Public Input No. 18-NFPA 291-2019 [Global Input]

Public Input No. 40-NFPA 291-2019 [Chapter 1]

Figure A.3.4.1 Dry Barrel Hydrant [NFPA 25:A.3.3.12.1]

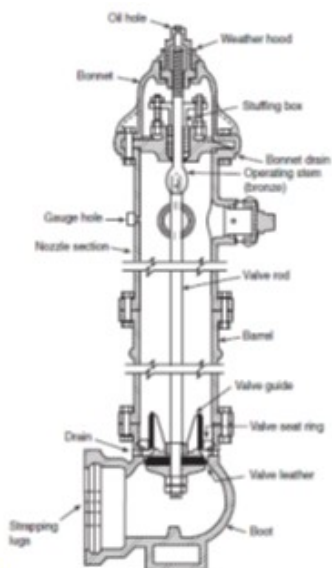
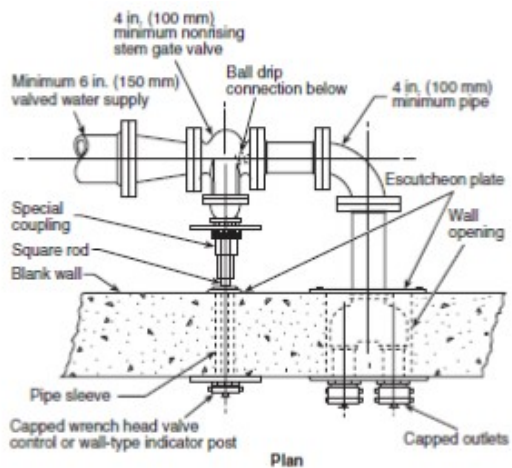
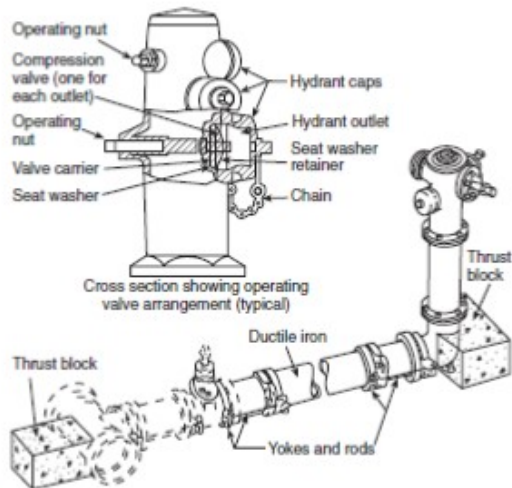
Also insert a new Figure A.4.4.1, a new Figure A.3.4.7 and a new Figure A.3.4.8 (extracts from NFPA 25) as follows:

This proposal is to provide definitions and illustrations for the various types of hydrants. Since this document is about hydrant flow testing and references different types of hydrants, it would be beneficial to include this information.

Figure 4.6.3 Pitot Tube Position.

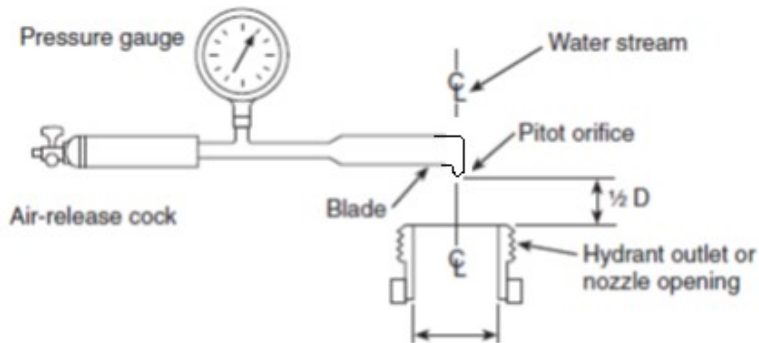
Delete the existing Figure 4.6.9 and replace it with the following new Figure 4.6.3:

Figure 4.6.9 Pitot Tube Position.

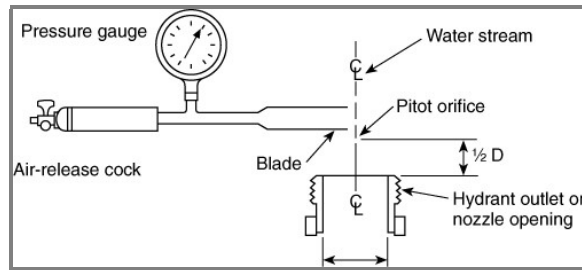
The existing Figure 4.6.9 is incomplete and does not show the tip of the pitot tube. The new illustration corrects this omission.

Figure 4.11.4 Sample Graph Sheet.

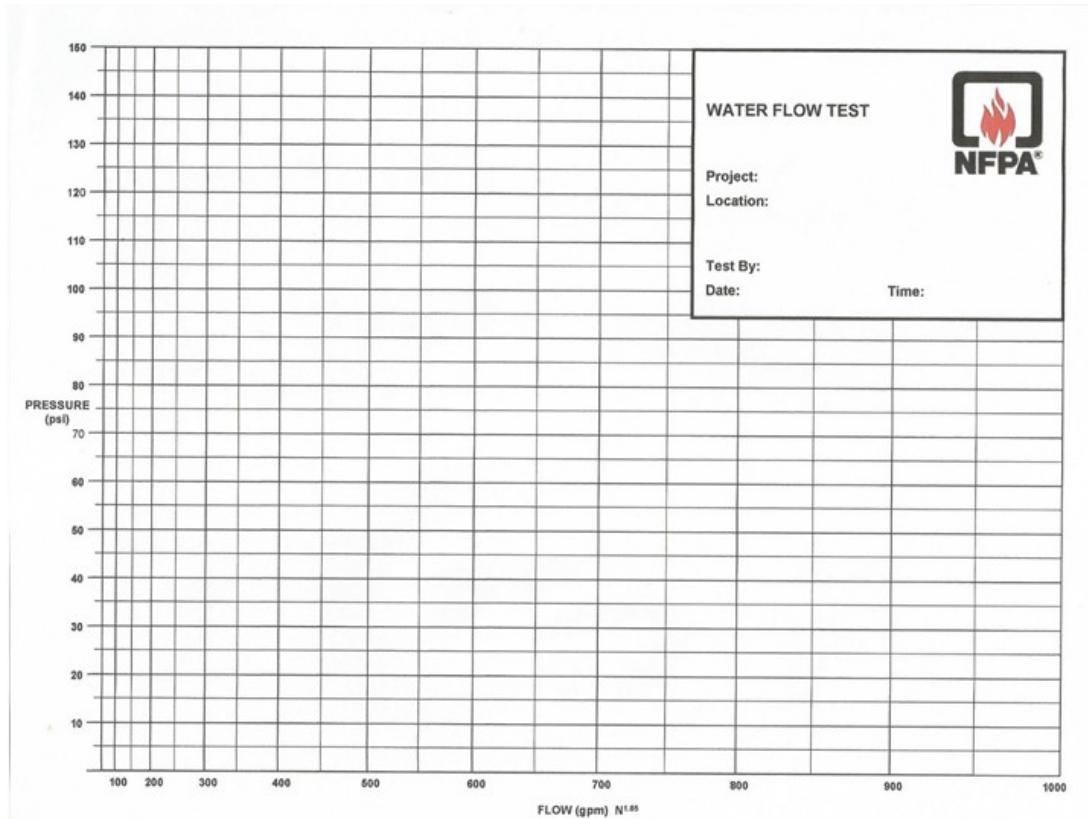
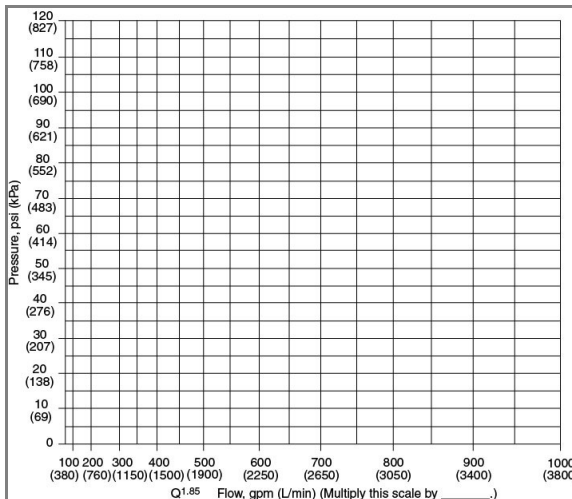
Delete the current Figure 4.11.4 and replace it with the following illustration:

This proposal is offered to provide a better version of a water flow test graph sheet.
